RA8P1 Group

Evaluation Kit for RA8P1 Microcontroller Group
EK-RA8P1 v1
Errata

EK-RA8P1 v1

Figure 2. Crystal Oscillator with Incorrect Load Capacitance

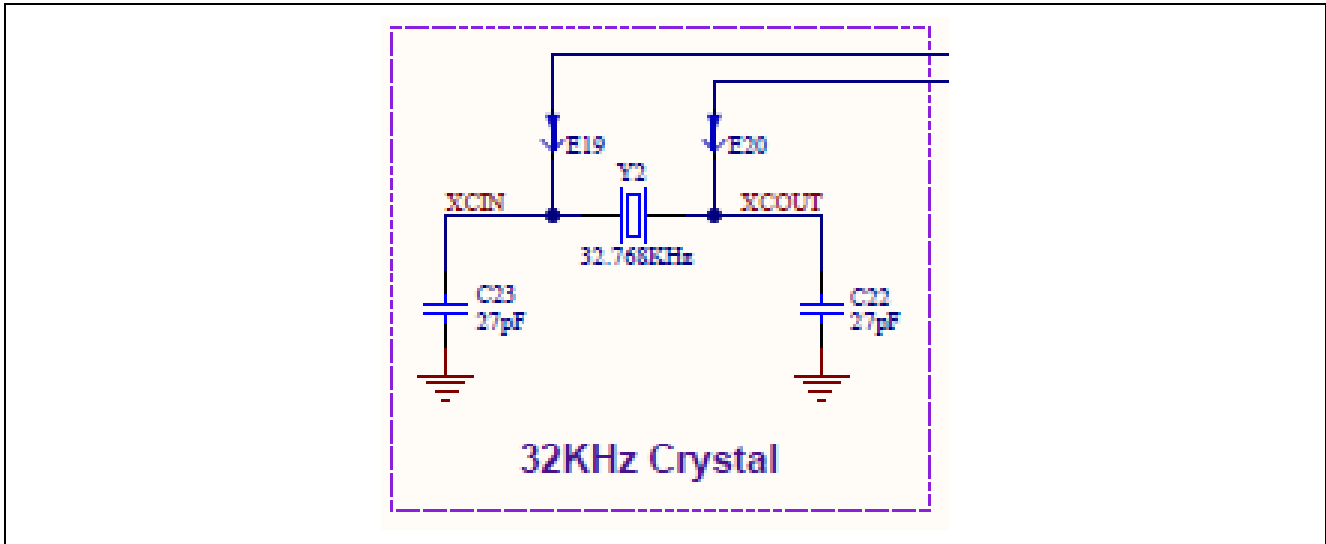
Due to incorrectly specified crystal load capacitance and capacitors C22 and C23 the RTC can be inaccurate in the order of 10 seconds every 24 hours. This is because the fitted crystal ABS07-32.768KHZ-9-T requires a 9pF load capacitance C_L , given by the formula $C22=C23=2*(C_L-C_{stray})$, and so the load capacitors C22 and C23 should be significantly lower values than the fitted 27pF capacitors.

To address this the user can replace the load capacitors, C22/C23, with 8.2pF parts, for example CC0402CRNPO9BN8R2. This value has been tested and found to be appropriate for the device and board configuration.

Figure 3. Touch Position Mapping Error

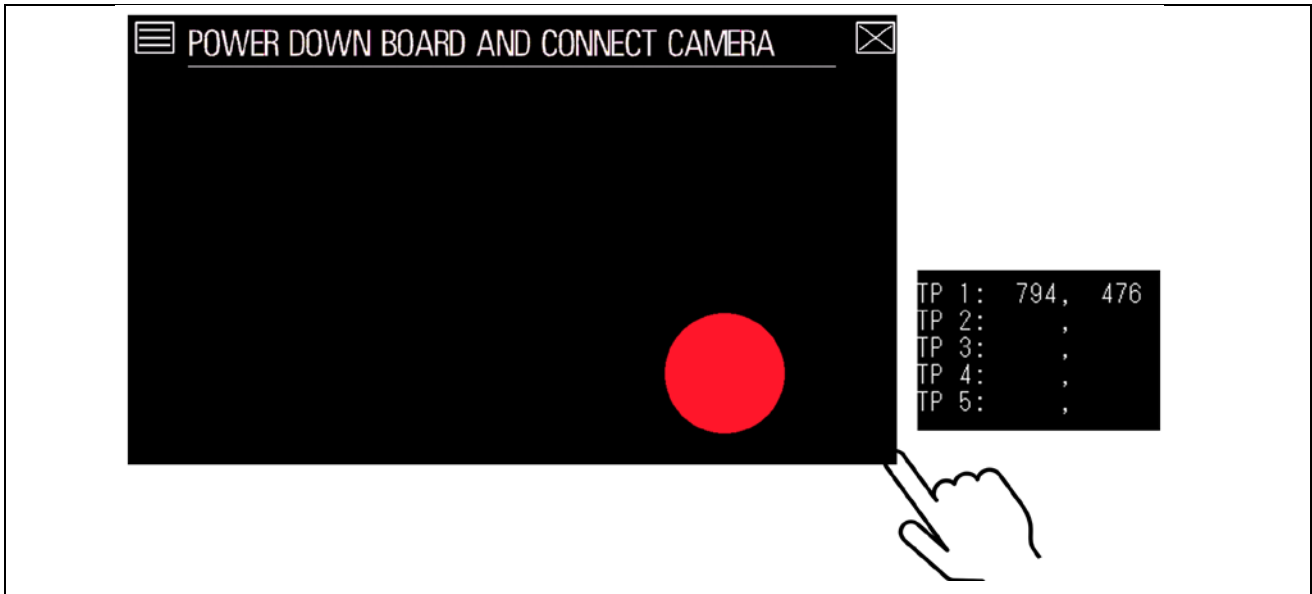
The Parallel Graphics Expansion Board screen has a resolution of 1024 x 600. The Touch Panel on a small number of kits may be incorrectly calibrated to 800 x 480 resolution. The user may find that touch position does not map to the correct position on the screen.

Please follow the steps below to address the issue.

1. Download the associated update package from our website. (r20zz0244eg0200-errata-ek-ra8p1-touchpanel_fix.zip) and extract the contents.
2. Download the latest version of Renesas Flash Programmer (RFP) from our website. (v3.21 or any later version).

3. Start RFP and open the project configuration file from the downloaded and extracted package. (ek-ra8p1_app_lcd_ek_par_1_touchpanel_fix.rpj)
4. Connect the EK-RA8P1 and the APP_LCD_EK_PAR_1 screen.
5. Connect the USB cable between the EK-RA8P1 Debug USB connector (J10) and your computer.
6. Press Start on the RFP dialog.
